## PLAT COMMITTEE

December 14, 2022

**Case Number:** 2022-PLT-088  
**Property Address:** 5212 Keystone Court (*Approximate Address*)  
**Location:** Washington Township, Council District # 9  
**Petitioner:** CNC Keystone Partners LLC, by Mark Leach  
**Zoning:** C-5  
**Request:** Approval of a Subdivision Plat to be known as Replat of Lot 2 in Keystone Court Minor Subdivision, a re-plat of a part of the east half of out lot 8 in Mallott Park, dividing 0.817-acre into two lots.  
**Waiver Requested:** None  
**Current Land Use:** Commercial Integrated Center  
**Staff Reviewer:** Allison Richardson, Senior Planner

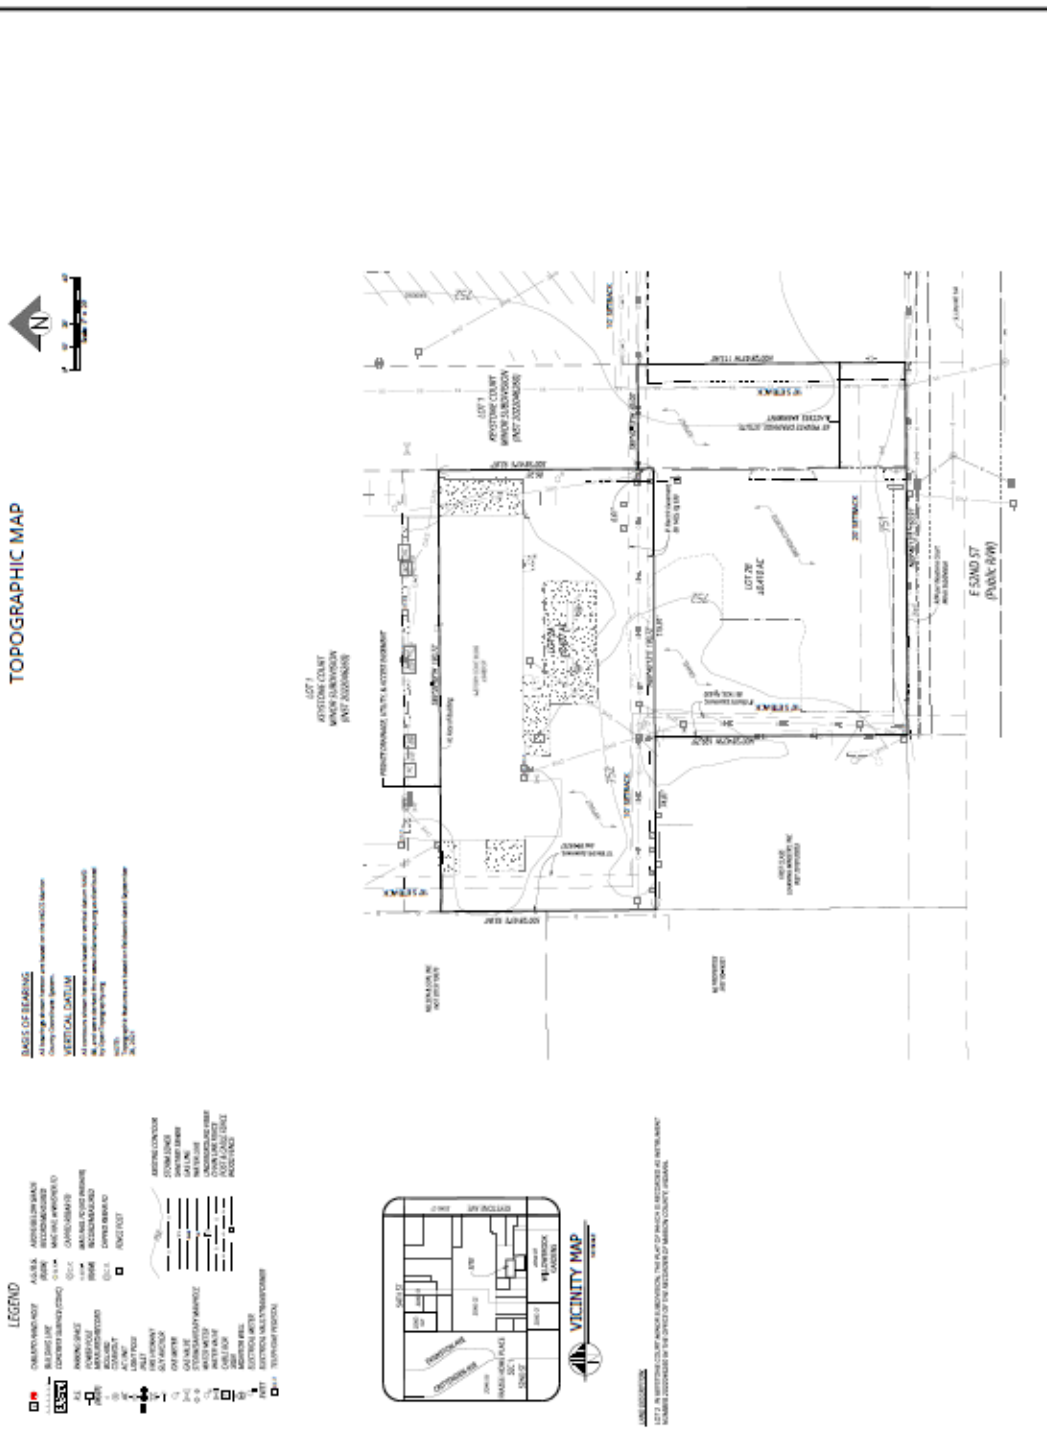
This site is zoned C-5 and developed with a commercial integrated center. This site was platted as Lot Two via 2022-PLT-009. The proposed plat would further subdivide Lot Two into two lots, Lot Two A and Two B. The proposed plat generally meets the standards of the C-5 zoning classification.

Lot Two B would front on 52<sup>nd</sup> Street. Lot Two A would be accessed via easement as shown on the preliminary plat. No new streets are proposed as part of this petition.

Staff recommends that the Plat Committee **approve** and find that the plat, file-dated November 4, 2022, complies with the standards of the Subdivision regulations, subject to the following conditions: Subject to the Standards and Specifications of Citizens Energy Group, Sanitation Section.
